**CITY OF HURON
HURON BOAT BASIN
FLOATING DOCK REPLACEMENT**

DATE OF ADDENDUM: July 6, 2026

ADDENDUM NUMBER: 03

ANTI-BINDING PIN DETAIL

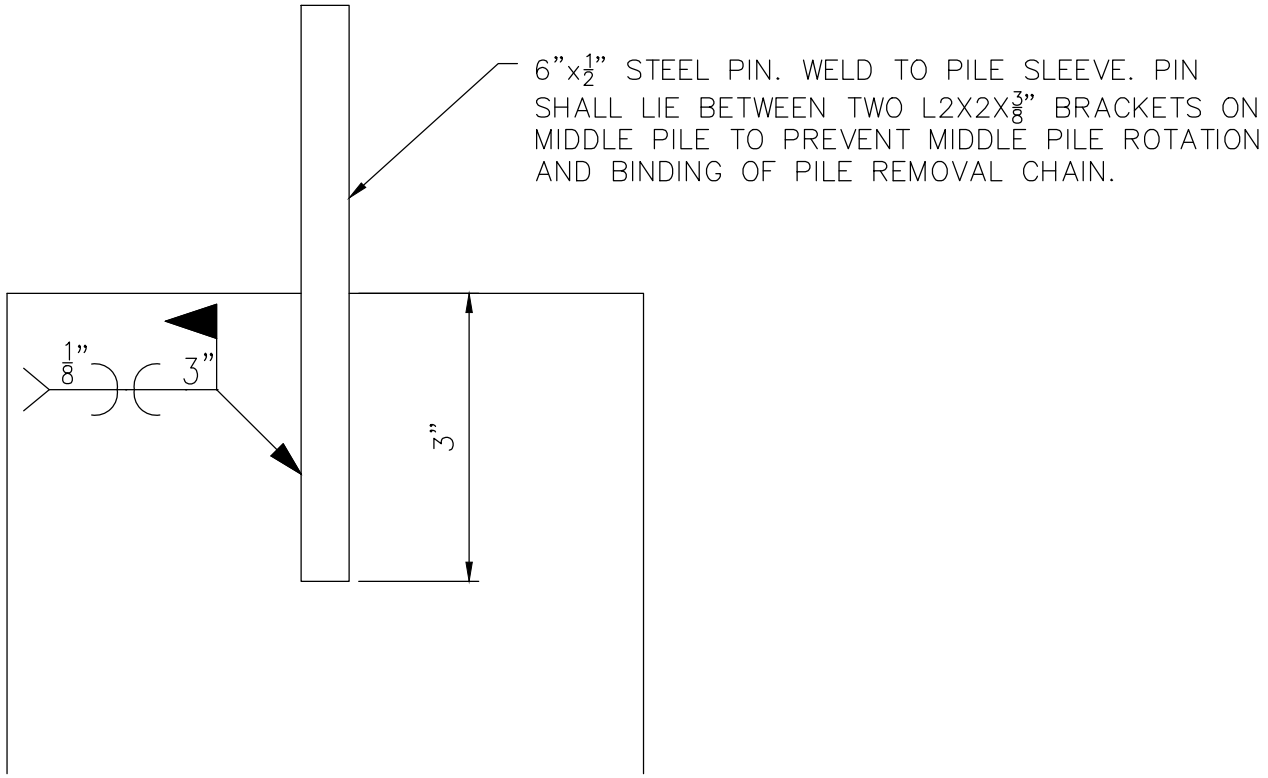
1. Sheet 16 is to be added to the Construction Drawings to provide details for the Pile Removal Chain and Anti-Binding Pin.

PILE REMOVAL BAR DETAIL

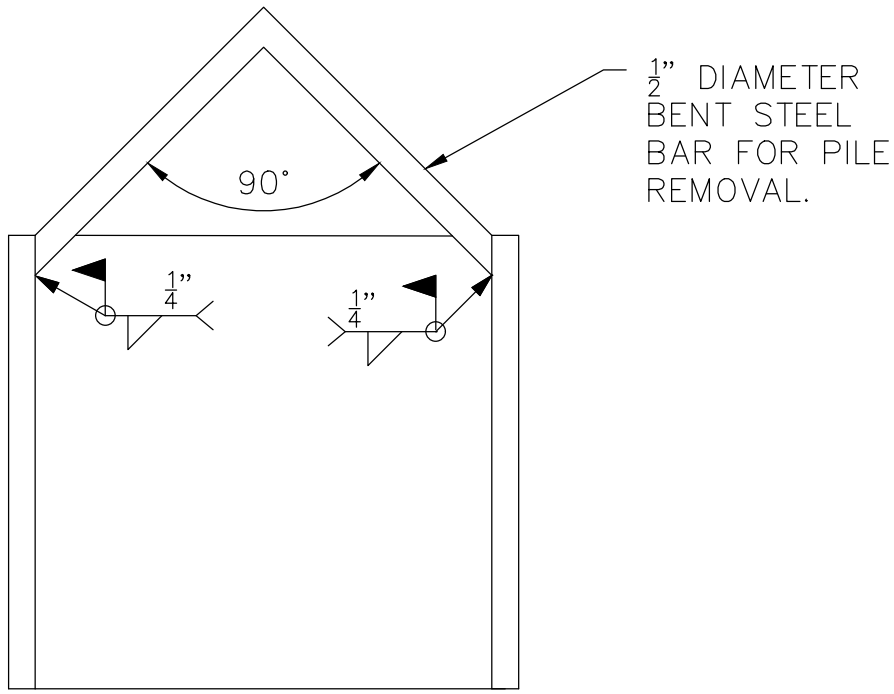
2. Can specifications for the pile removal chain, including chain size, material requirements, and attachment details to the anchor pile be provided?

Response: The pile removal chain shall 3/8-inch open link hot dipped galvanized Grade 70 steel chain with minimum working load limit of 5,000 lbs.
